VEHICLE DEFECT

IMPORTANT SAFETY RECALL

Subject: 6-Point Seatbelt / Transit and Sprinter Type II / Modification Safety Recall Notice

Subject: 6-Point Seatbelt / Transit and Sprinter Type II / TEMPORARY Modification Instructions

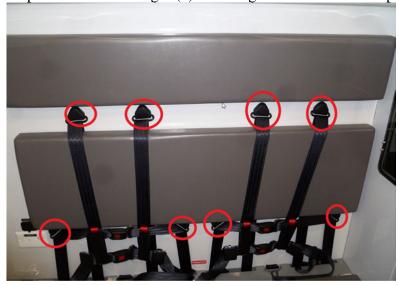
Ambulance owners must have anchorage sub-assemblies inspected and PERMANENTLY modified by an authorized technician.

Step #2 - Torque each bolt at 25 lbs/foot and re-install plastic cover

Step #3 – Schedule permanent modification with authorized technician
